**Summary of response of Save the Northfield Depot (STND) re:  
2-14-23 Schematic Design of Pavilion and Transit Hub<sup>1</sup>**

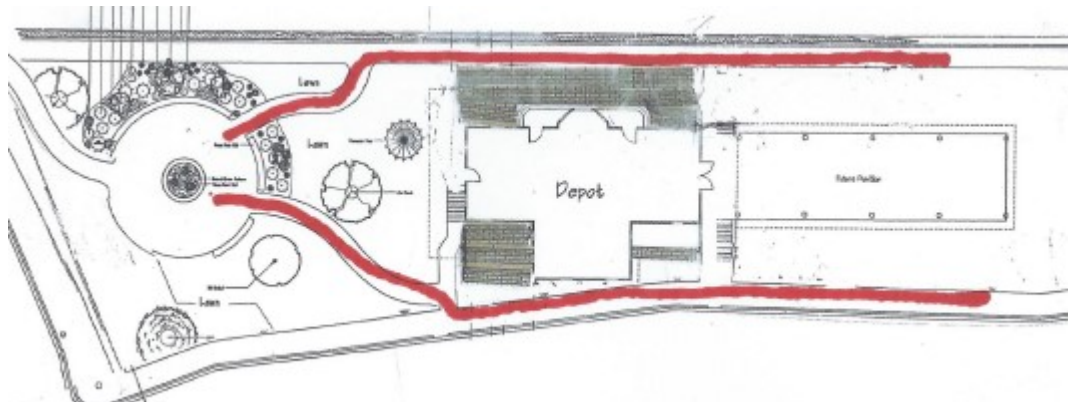
Our preferred roof plan (see below): We propose that the roof of the pavilion and the roof of the depot be adjacent with one gutter system that runs the full width of the pavilion overhang (vs. smaller proposed connecting structure). This plan would address our concerns as follows:

Safety: This design would be much safer by eliminating the four roof valleys and significantly reducing the steps and plaza floor area vulnerability to water and icing.

Integrity. A gutter is not a permanent feature (similar to a solar panel that is allowed on an historical building because it is not permanent and part of the structure), thus, it would not compromise the integrity of the depot.

Aesthetics. A smooth visual transition from one building to another is less distracting and much more in harmony with one another. The roof lines of the depot and pavilion do not compete.

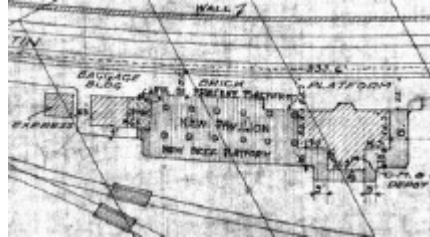
It is not clear from the 2-14-23 drawings that the pavilion is wider than in the first plan. At the first planning meeting there seemed to be a general endorsement of creating a flexible event space vs. a passage in the pavilion as drawn:-

This could be achieved by placing the pavilion columns to be even with the outside E and W walls of the depot (see 1917 drawing below). The overhang on the east side may then provide some weather protection for the ramp; the overhang on the west side could provide protection for bike racks.
